KINGSTON FOSSIL PLANT - ANNUAL ASH POND DIKE STABILITY INSPECTION

ANNUAL ASH POND DIKE
STABILITY INSPECTION

Prepared by: Michael S. Hughes, P.E.
Date: March 29, 2006

Picture 12: Typical vegetated banks outside dredge cells

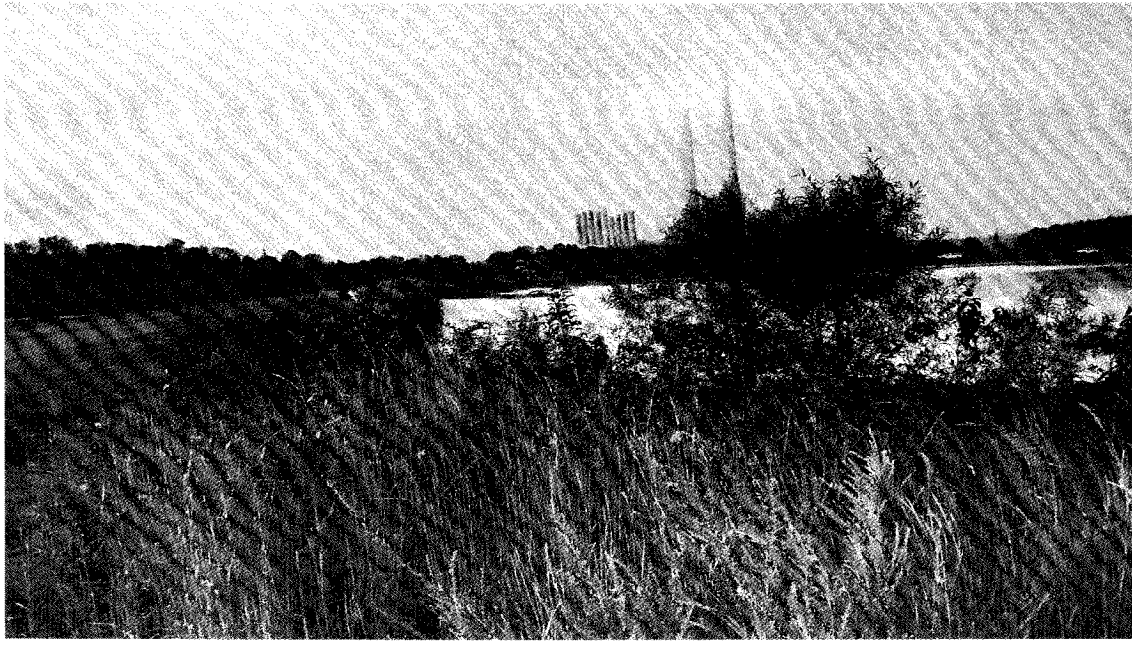
All exterior dike slopes around this area appeared to be in sound condition with excellent vegetative cover (see Picture 12). The dikes were in need of mowing. Small trees had grown to a height of 3 to 5 feet in some places. These trees should be pulled up and the area reseeded. Presently the dikes are mowed only once a year.

Picture 13: Vegetation in divider dike (ash pond side), note small trees in dike

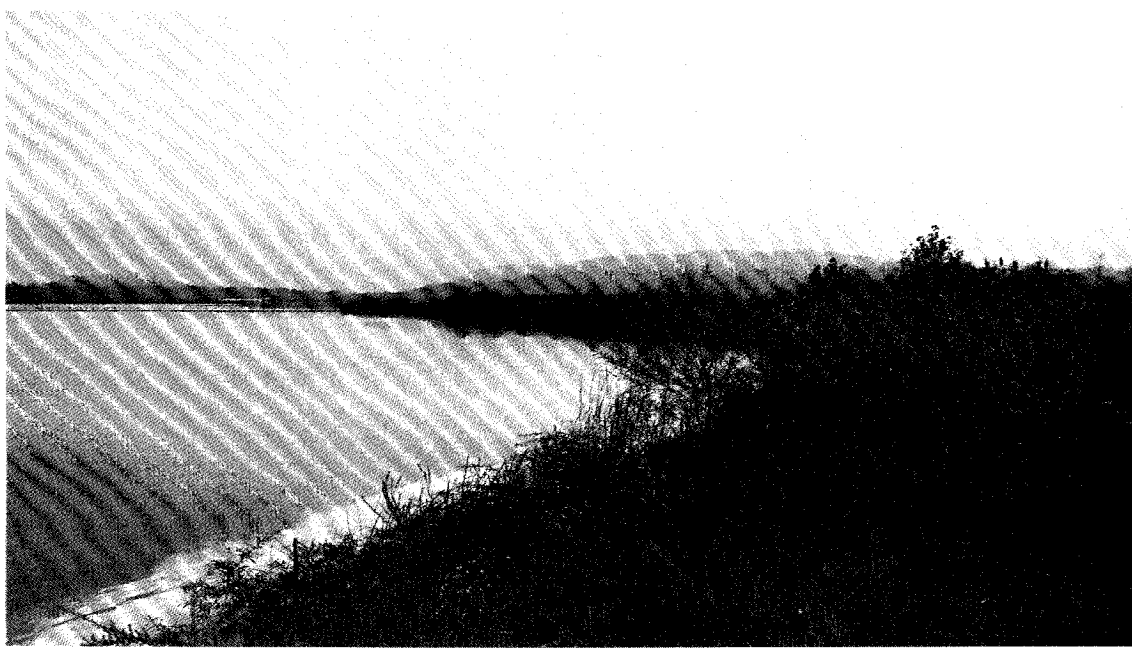
The divider dike between the active pond and the stilling pool had some areas of erosion and gullies, but appeared stable otherwise. The divider dike on the ash pond side needs mowing and some small trees pulled up (see Pictures 13 and 14). These areas of the dikes at the new spillway construction should have rip-rap placed to minimize erosion from potential wave action.

- The divider dike between the ash pond and the stilling pool shows signs of erosion on the ash pond side. These slopes should be rip-rapped to stabilize.
- Trees on the divider dike on the ash pond side and the stilling pool side should be mowed or pulled up and the area repaired and reseeded.
- Dredge cell drainage ditches should be kept free of cattails. Any existing cattails should be cut.

Picture 15: Floating Pump platform at coal yard drainage basin (grounded)

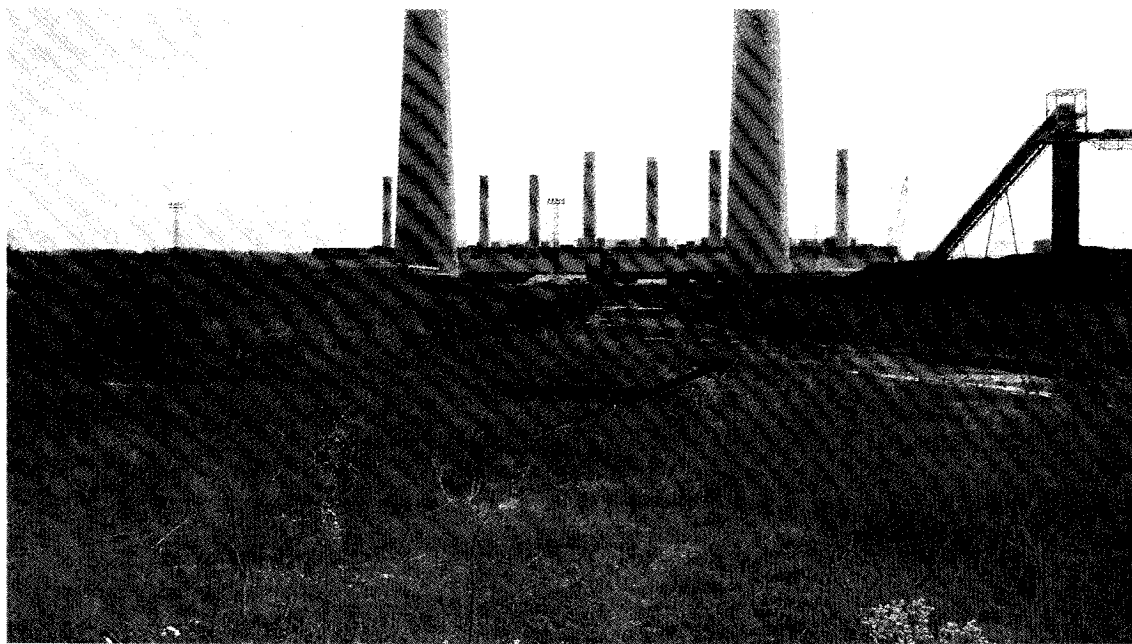
The coal yard drainage basin is located at the southwest corner of the coal pile. This basin was excavated below grade; therefore, there are no exterior dikes. The interior slopes appeared to be in satisfactory condition. Normal discharge from this basin is pumped into the fly ash discharge ditch and flows to the active ash disposal area. At the time of inspection, water in the pond was at a low level, about 6" below the first pump start switch and the platform was grounded (see Picture 15). The basin was sounded at 5 places and the depths are indicated on the attachment API 2006-2. This indicates the sediment in the bottom is taking more than 50 percent of the basin's storage capacity. This represents a 1.67 feet increase in sediment depth since the last inspection. The basin was dredged just over three years ago, but it is recommended that dredging the basin occur annually. The bottom of the pond should be no higher than elevation 745 at the pump platform. Elevation 745 allows 2 feet of clearance below the pump intakes to prevent the pumps from pumping solids; the elevations indicate the pumps have been pumping solids for some time. In addition, the "V-shaped" pond extensions added during the summer of 2001 to increase the pond storage volume contained coal yard sediment (see Picture 16). TVA drawing 10W225-2 (attached as API 2006-2) shows the pond and its intended bottom contours.

- Dredge the Coal Yard Drainage Basin to restore its design contours and protect the pumps from further damage. There is an estimated 2,800 cubic yards of sediment in the original pond and an extra 3,400 cubic yards in the "V" section that needs to be removed as soon as reasonable. See the attached copy of 10W225-2.

Picture 16: Coal yard runoff channel, note the sediment

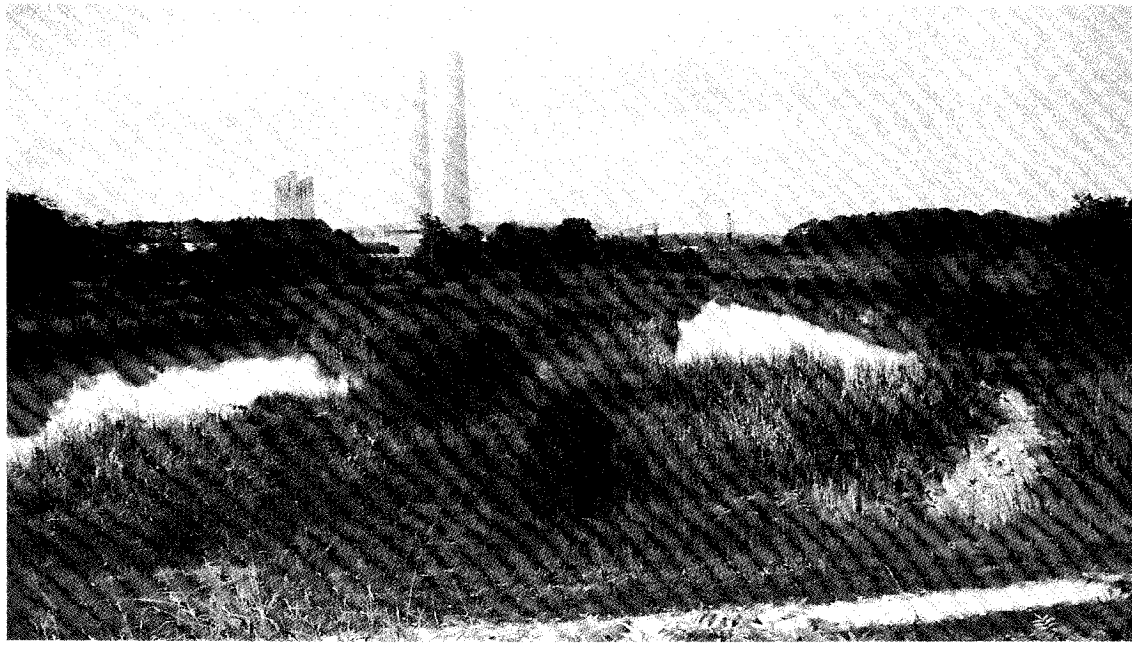
We understand that others are taking a more precise survey of the Coal Yard Drainage Basin to more accurately assess the situation. these spot elevations indicate a need for dredging.
